HENZLEE PLACE STREET
IMPROVEMENT PLAN

HENZLEE PLACE STREET IMPROVEMENT PLAN

SOPHIA LANE STREET IMPROVEMENT PLAN

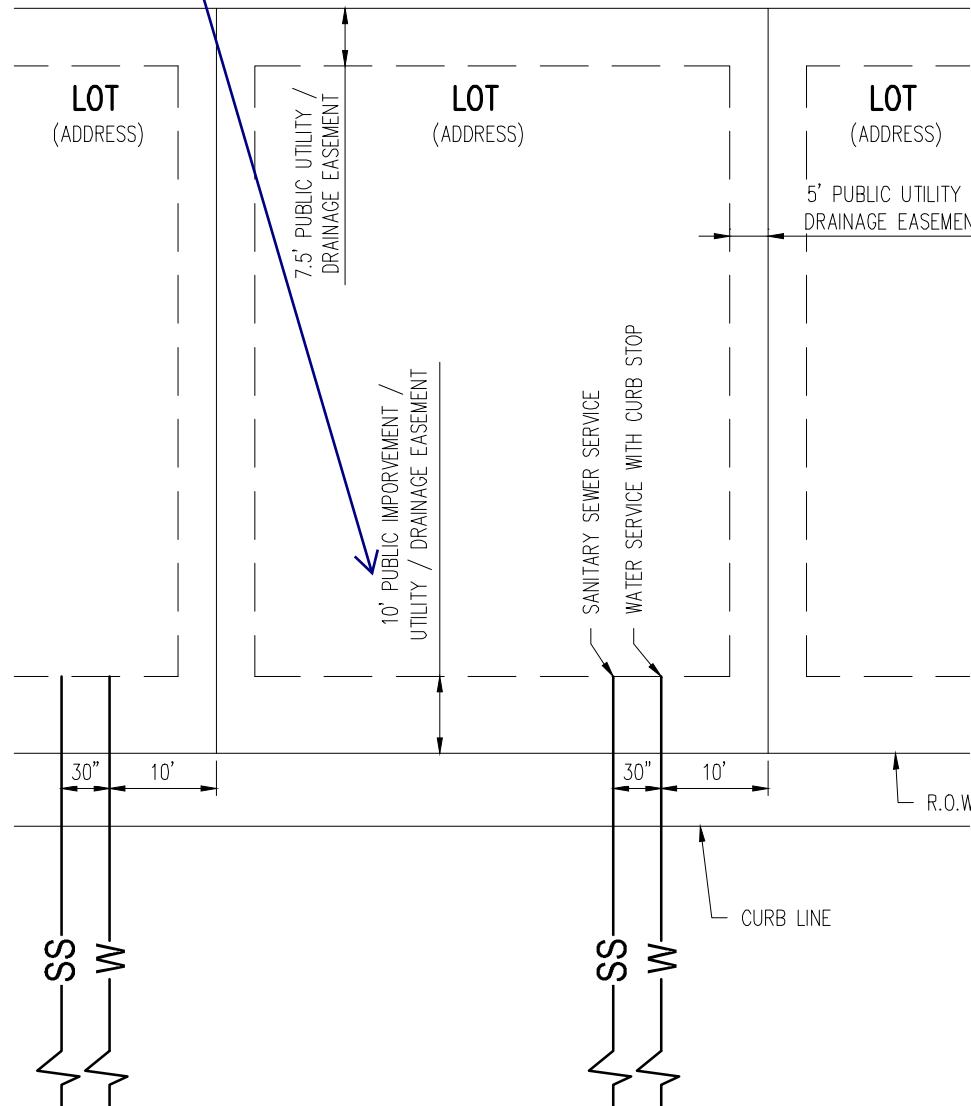
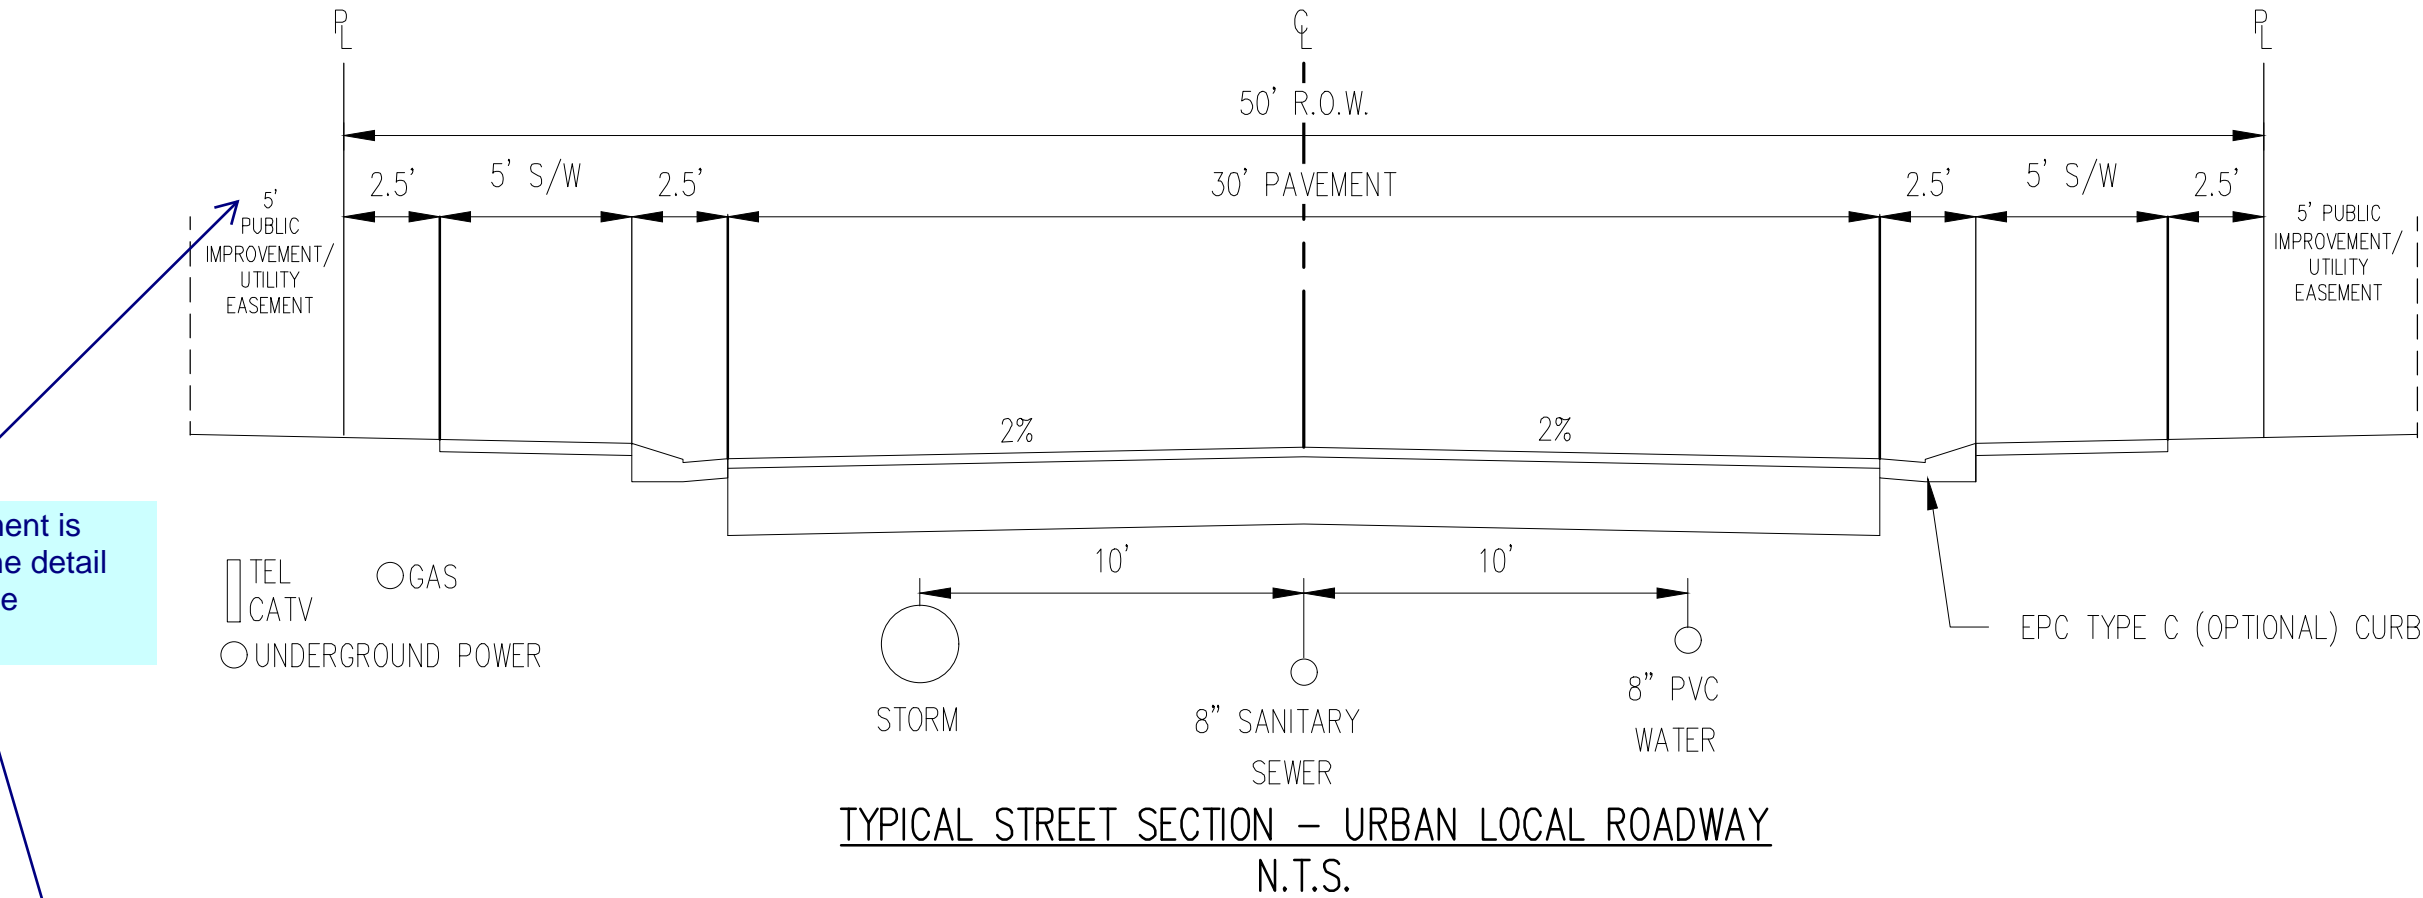
a 10' easement is shown on the detail below, revise accordingly.
